**SODERHOLM AND ASSOCIATES BUILDING**  
ADDITION SITE PLAN

**GRADING AND EROSION CONTROL PLAN**  
CITY OF RAMSEY, MINNESOTA

UTILITY.pdf V2 - Changemark Notes ( 5 Notes )

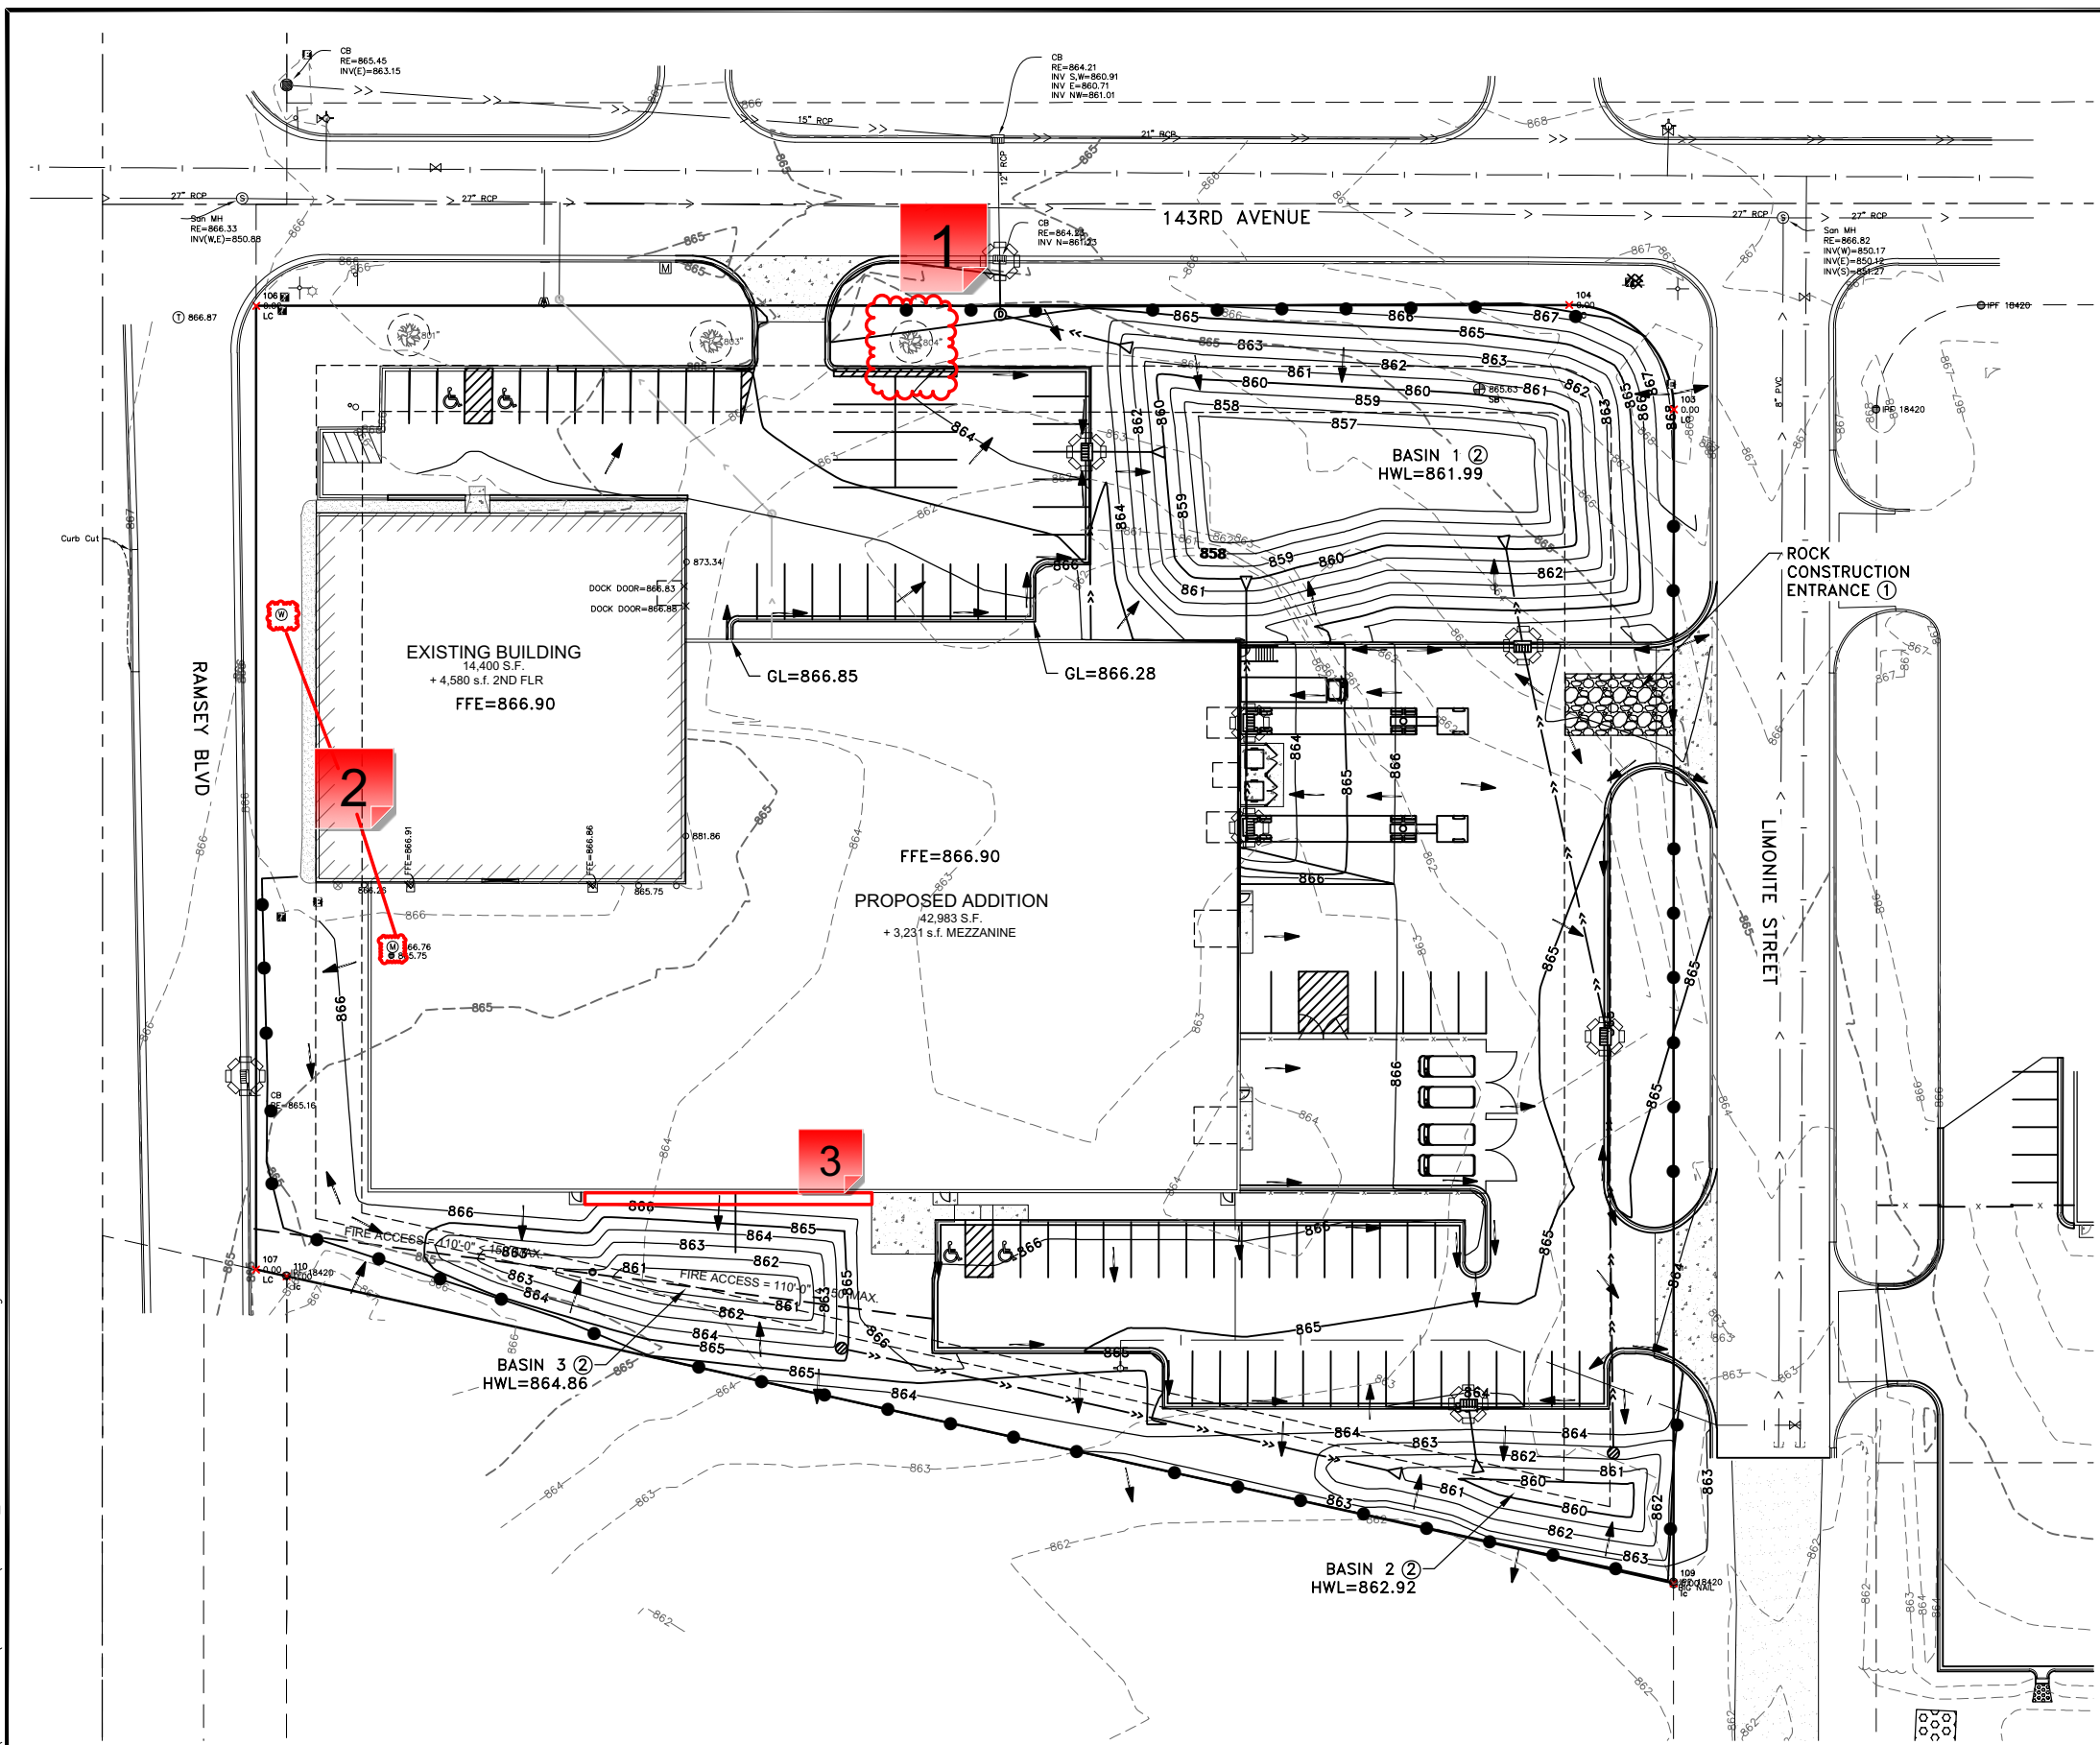
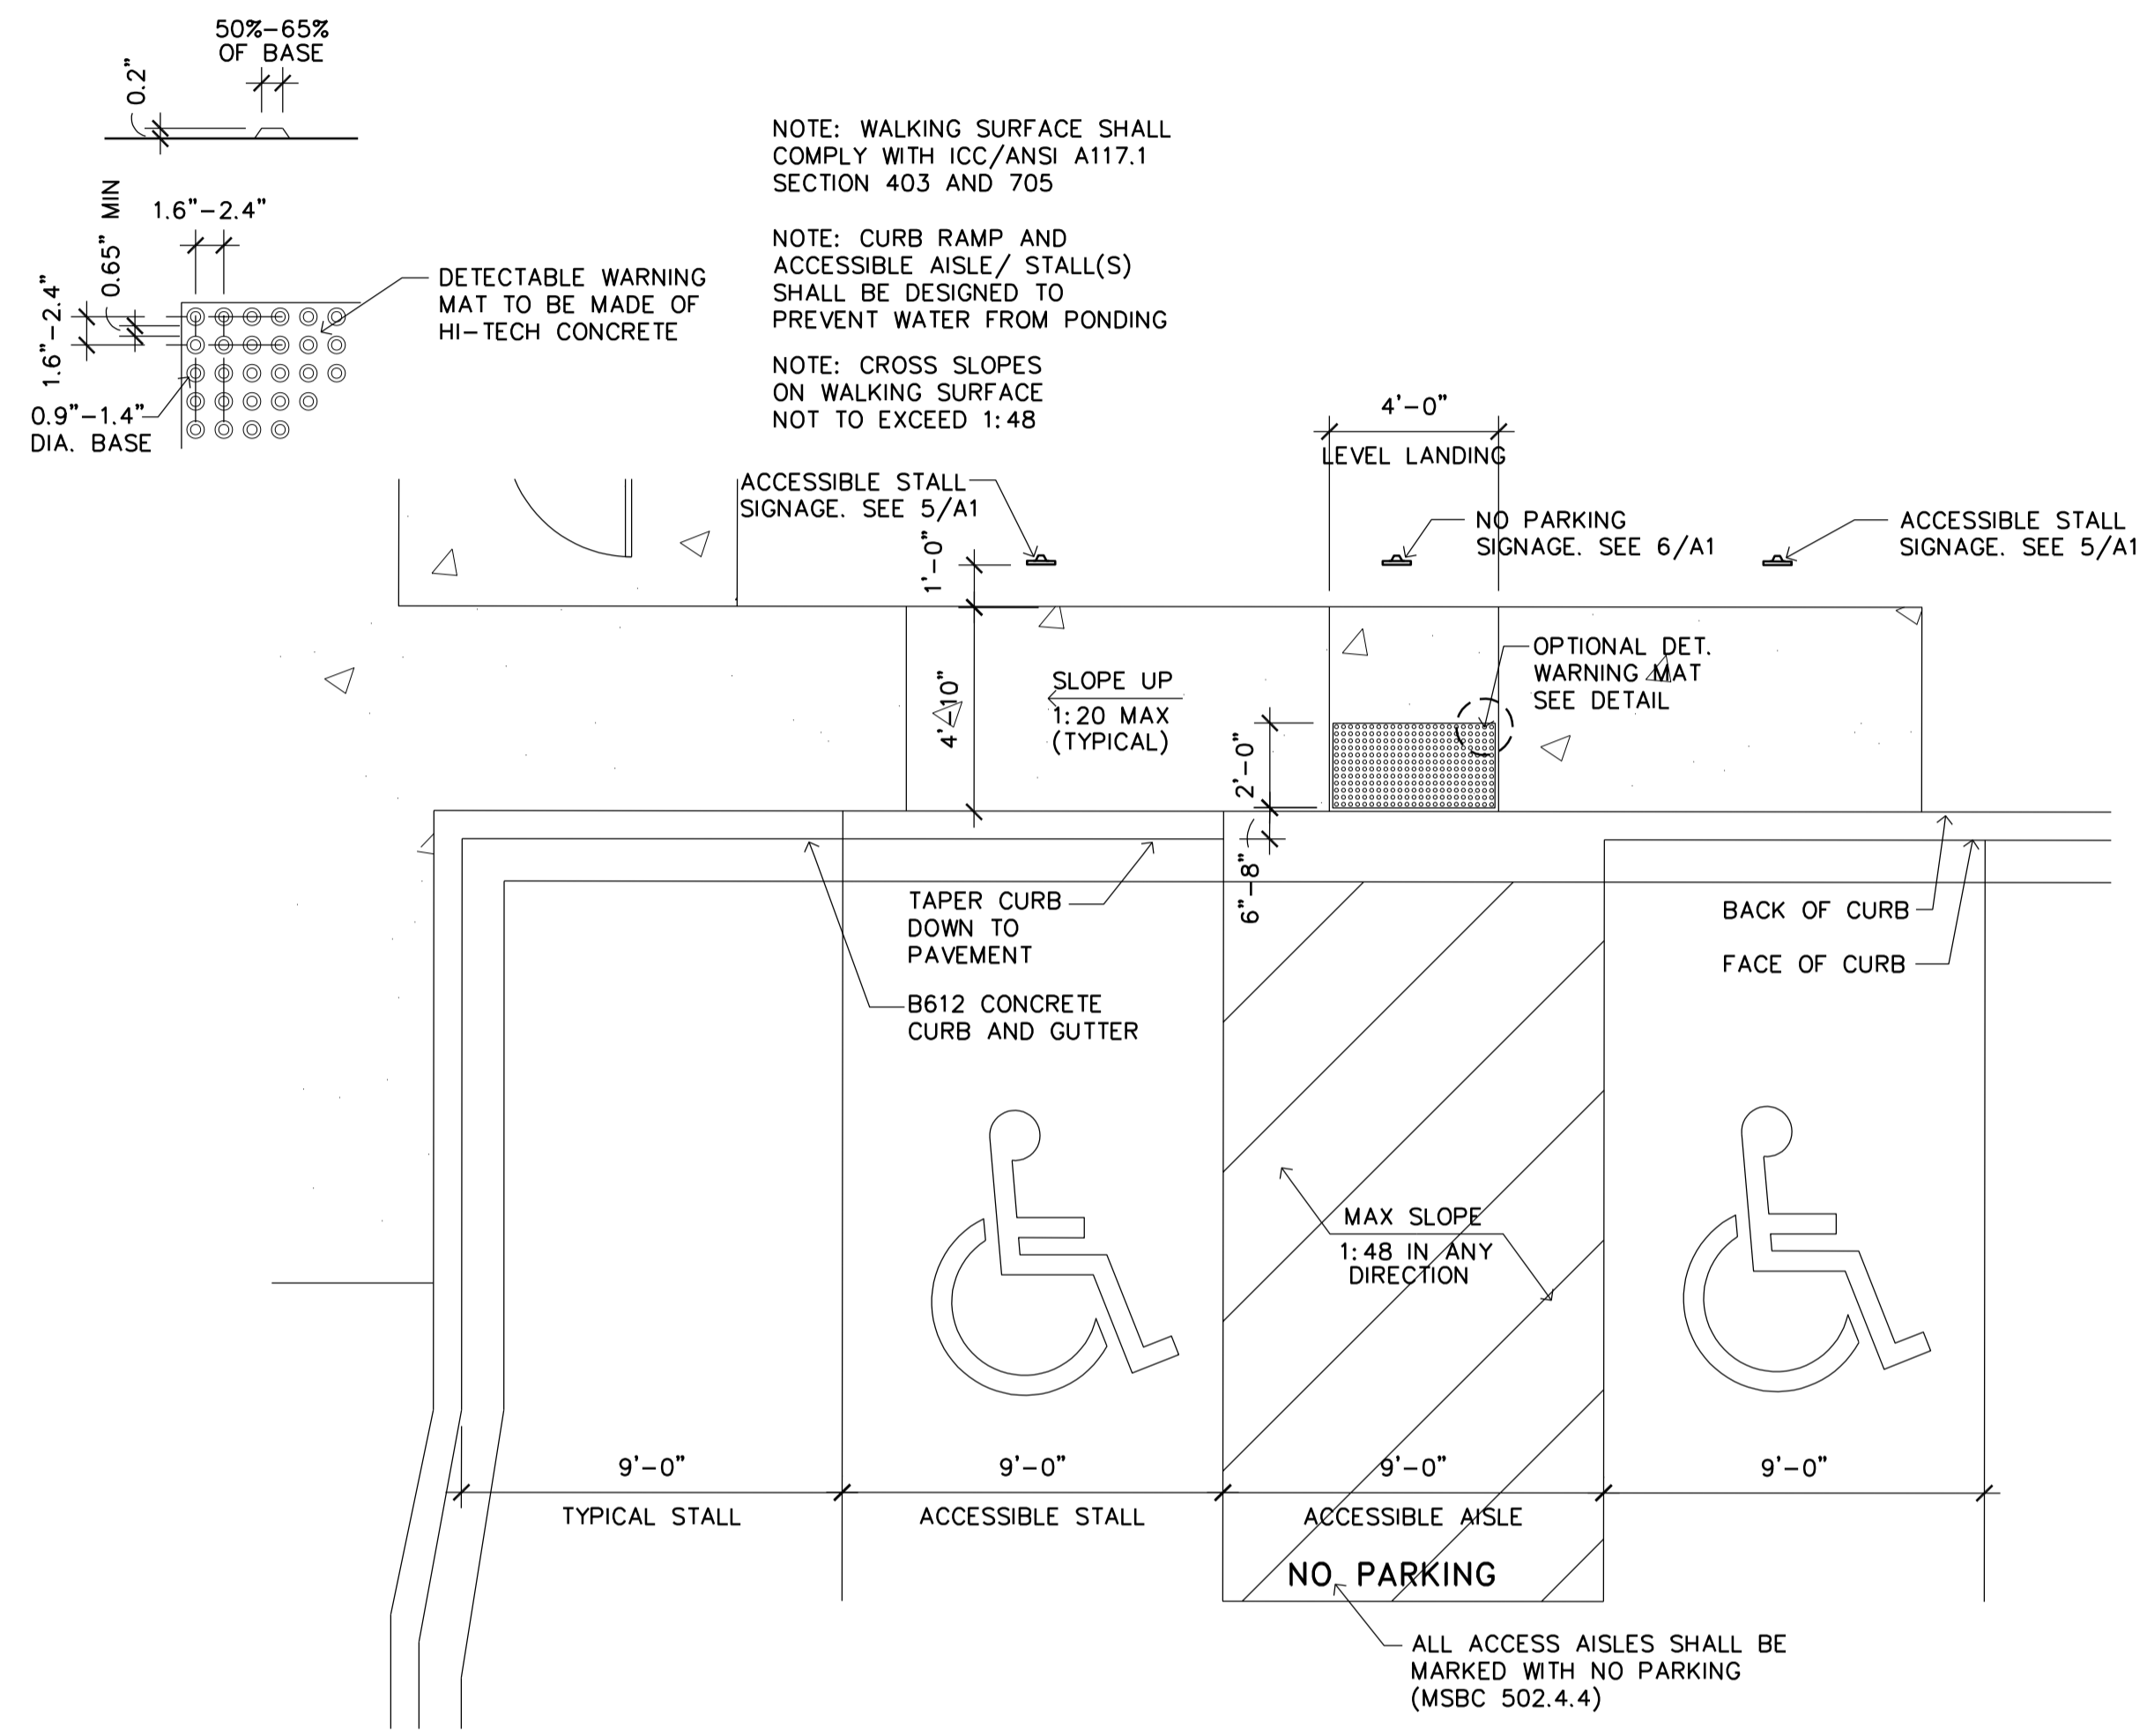
### 1 - Grading

No grading can occur within the tree save fencing. Tree save fencing shall be installed no closer to the trunk of the tree than the dripline.

### 2 - Add to Legend

Add these symbols to the legend of each plan sheet.

### 3 - Fire Access

Show the proposed paved walkway on all plan sheets as it's shown on Sheet A1.

SITE PLAN

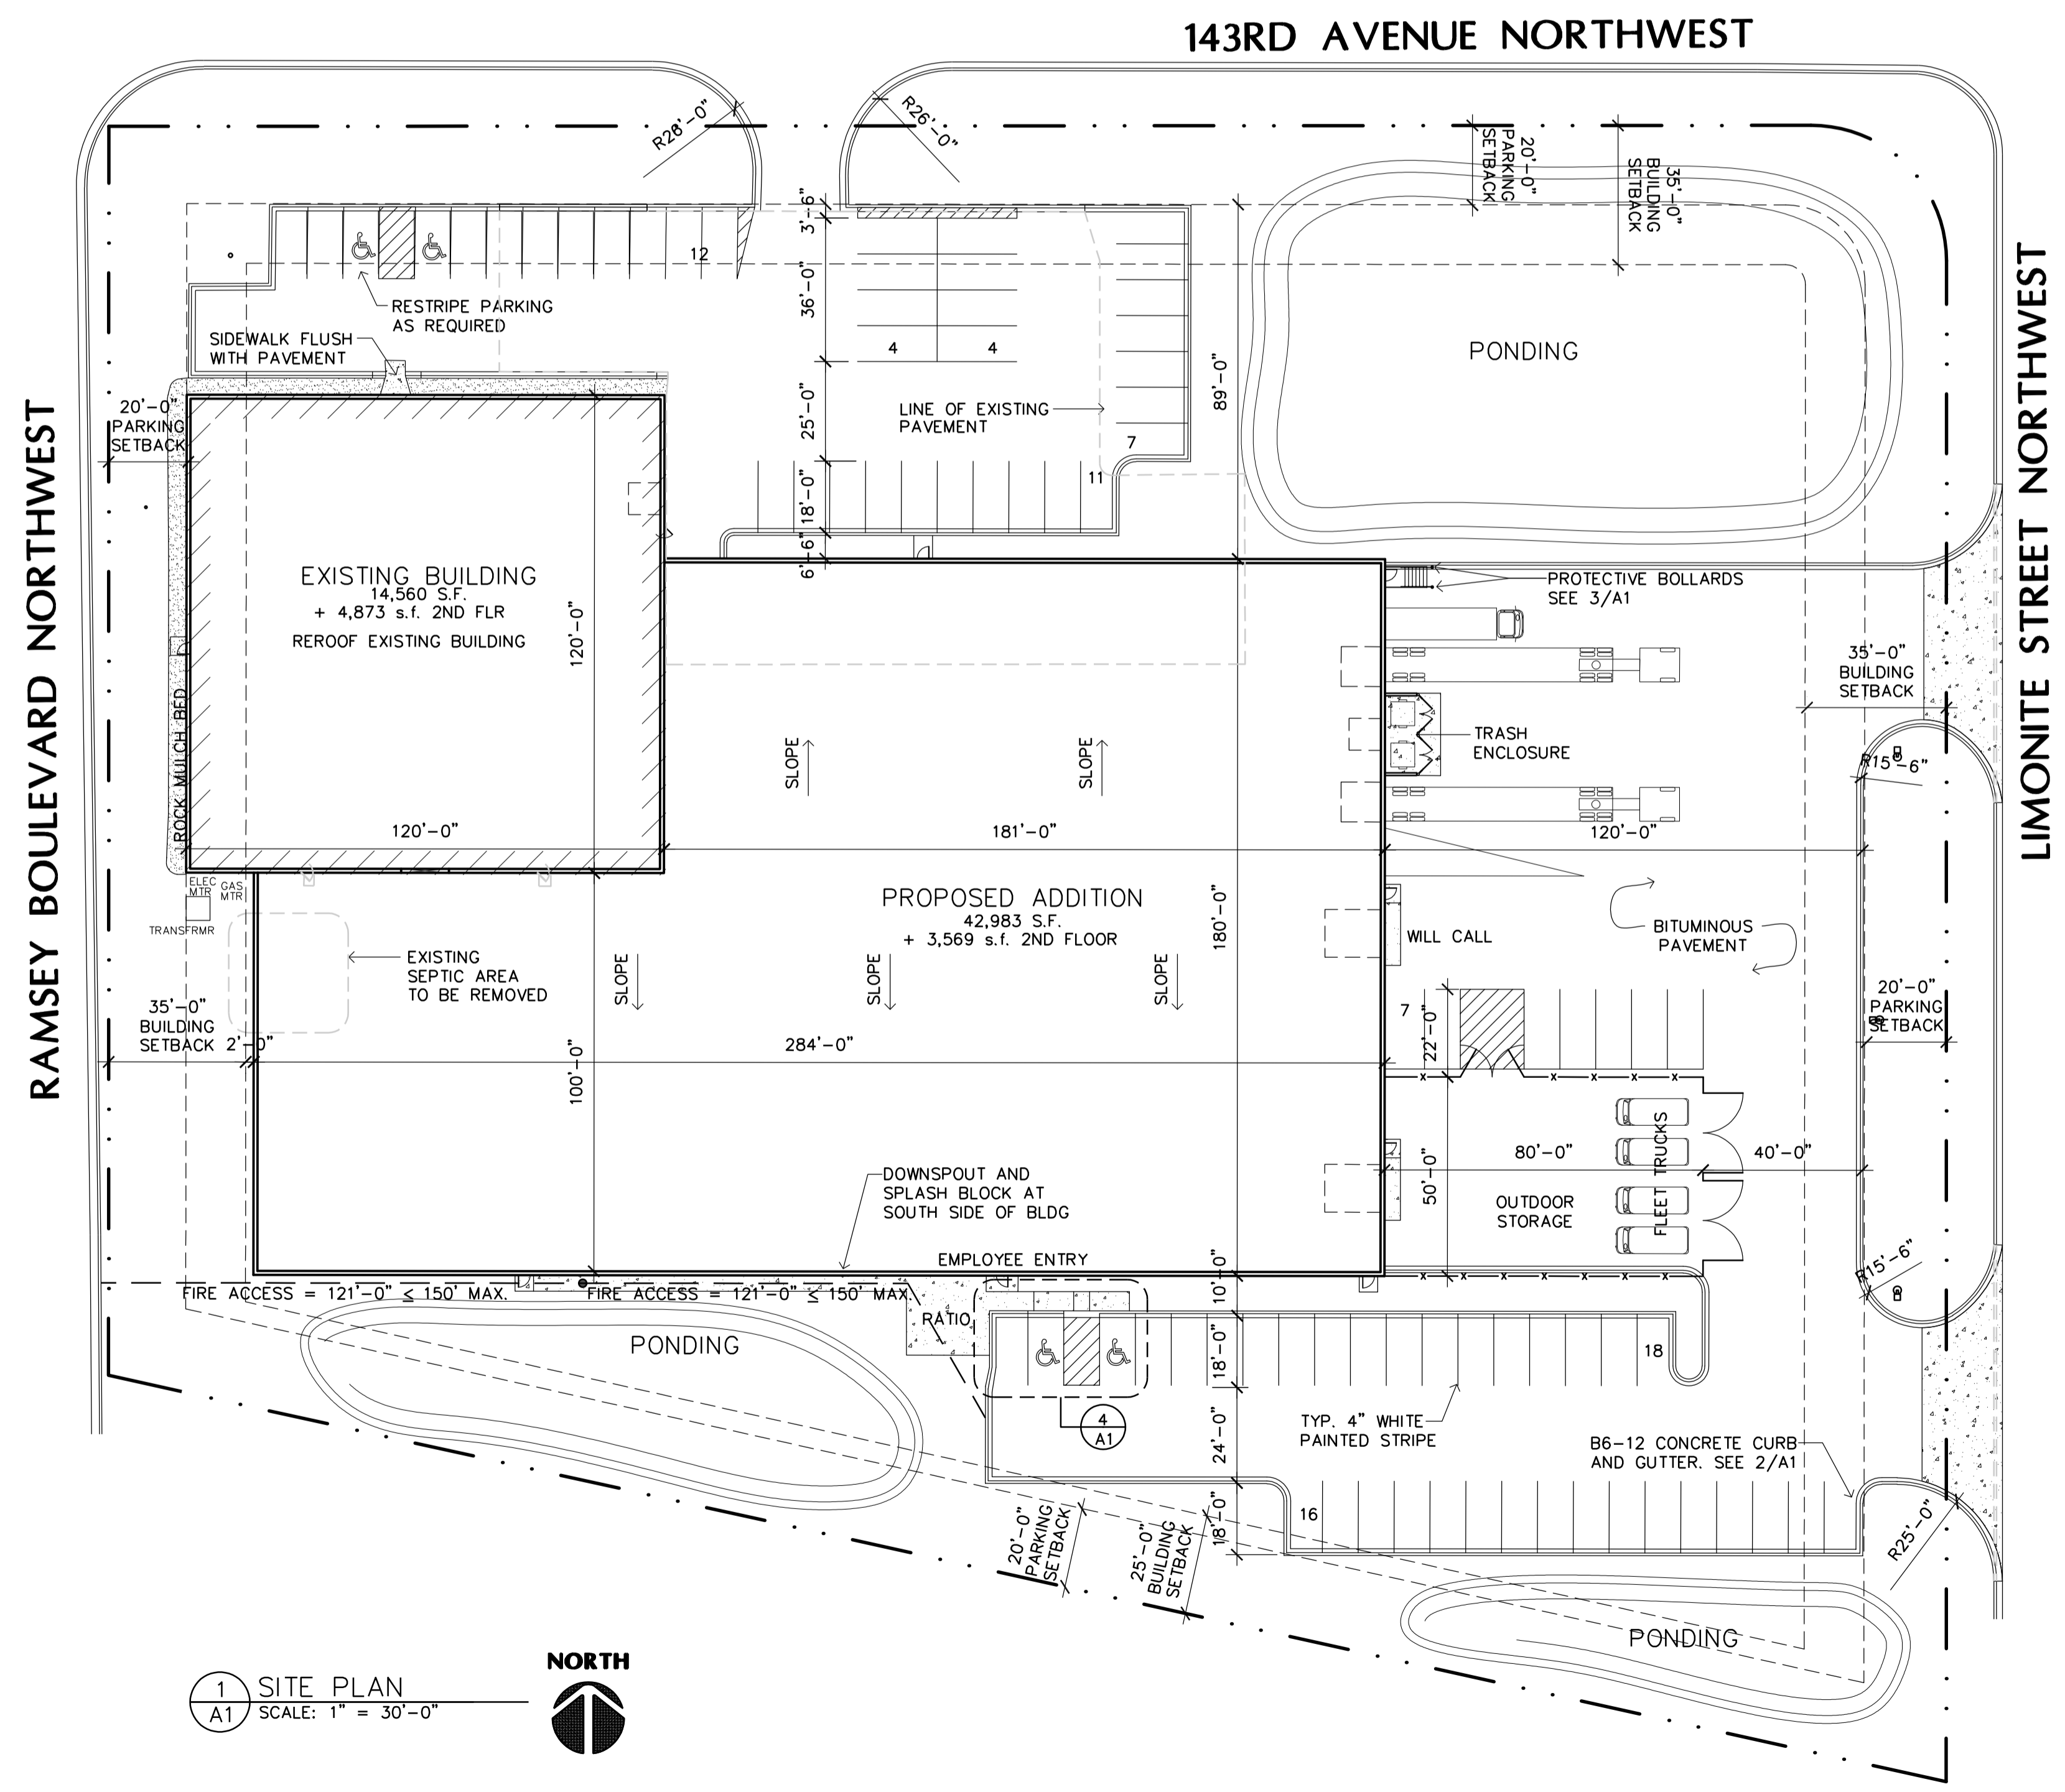
## 1 - Site Data and Parking Data

Please add back the parking and site data that were included on the initial submittal. The zoning designation for this property is E-2 Employment District.
